Revised Pages

Safeguards Report for the
Supercritical Technology Program

These revised pages incorporate modifications to the Supercritical Loop as described in the Safeguards Report

FIGURE 2
SAMPLE SYSTEM FLOW DIAGRAM

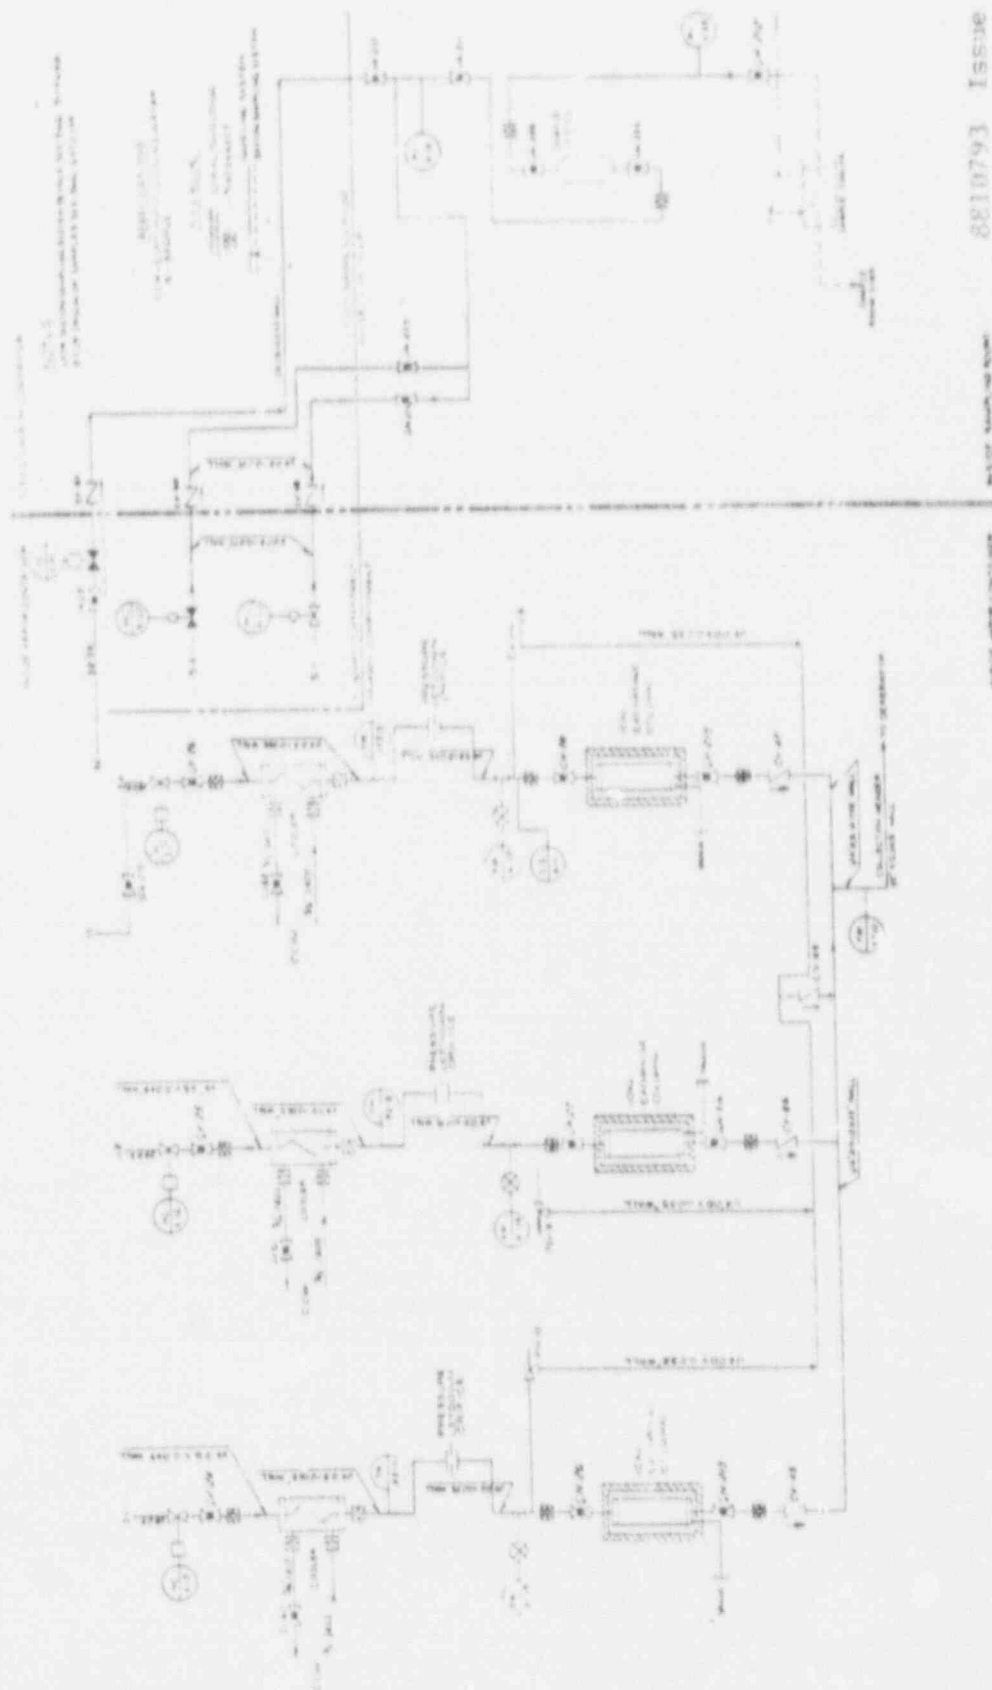
Each sample stream flows through a sample cooler, then through a pressure reducing restriction into a mixed bed sample ion exchanger. The sample pressure reducing valves have been replaced by capillary tubing restrictions to eliminate the uncertainty of letdown valve operational reliability for such low volume flows.

23. Revised Figures 1 and 2.
